STATE OF CONNECTICUT
CONNECTICUT SITING COUNCIL

APPLICATION OF SBA TOWERS III (SBA)
AND NEW CINGULAR WIRELESS PCS, LLC
(AT&T) FOR A CERTIFICATE OF
ENVIRONMENTAL COMPATIBILITY AND
PUBLIC NEED FOR THE CONSTRUCTION,
MAINTENANCE AND OPERATION OF A
TELECOMMUNICATIONS TOWER FACILITY
AT WEWAKA BROOK ROAD IN THE TOWN
OF BRIDGEWATER

DOCKET NO. 412

SBA TOWERS III ("SBA") AND NEW CINGULAR WIRELESS PCS, LLC ("AT&T")
RESPONSES TO SITING COUNCIL INTERROGATORIES
SET I

Closest Important Bird Area: Good Hill Farm Preserve (4.5± miles northeast)

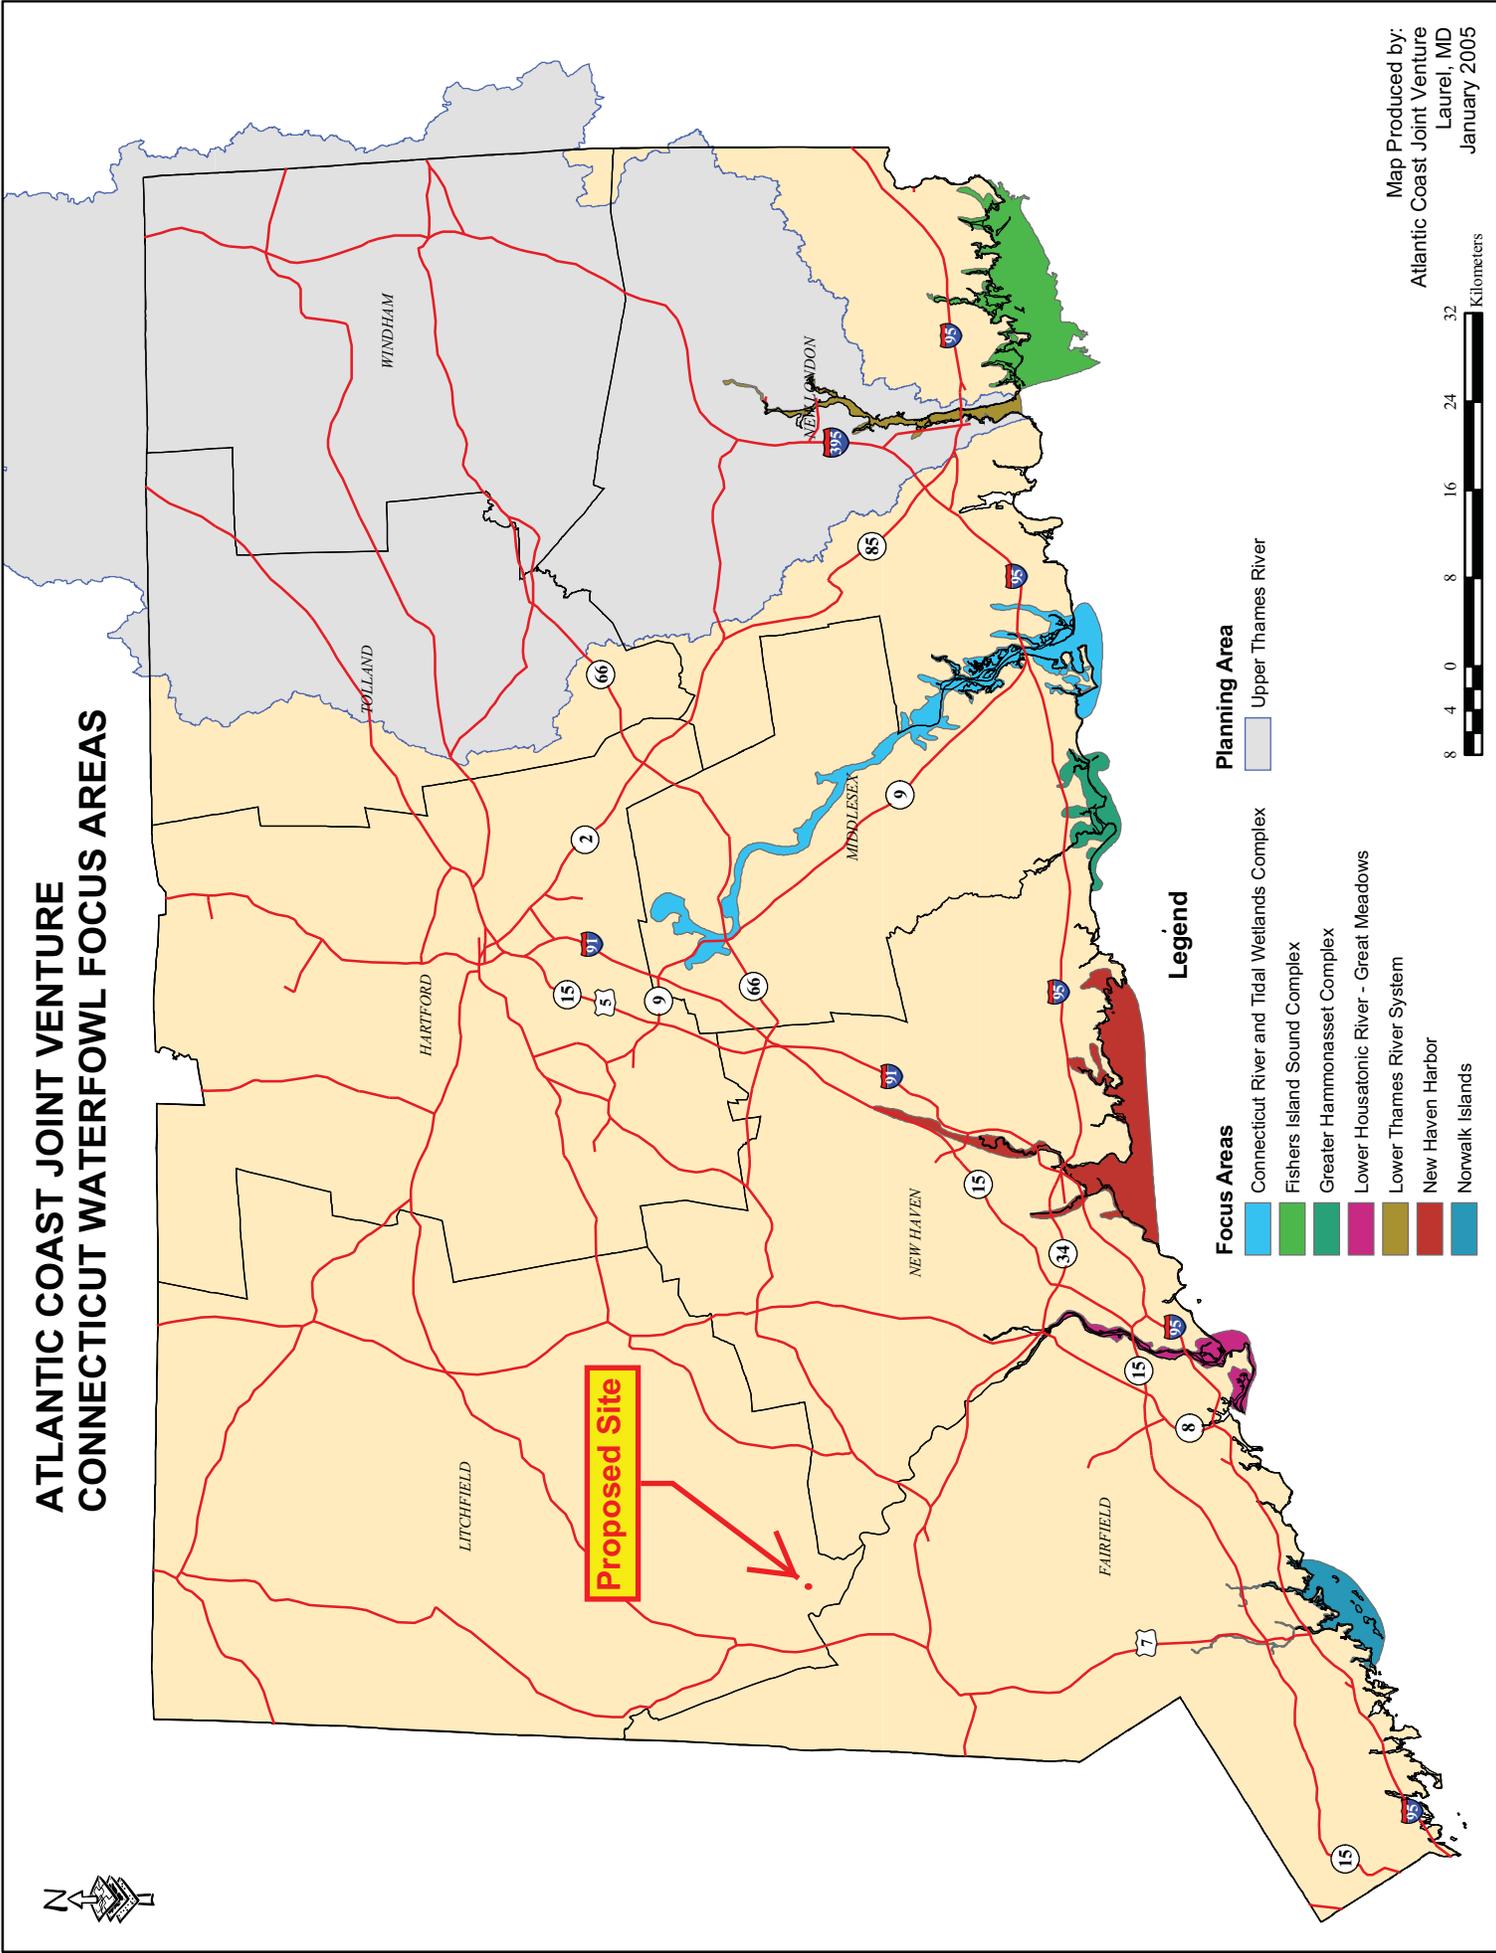
Q21. Is the proposed site within an "Important Bird Area" as designated by the National Audubon Society?

A21. No. Please see the March 7, 2011 Memorandum prepared by VHB included in Attachment 6.
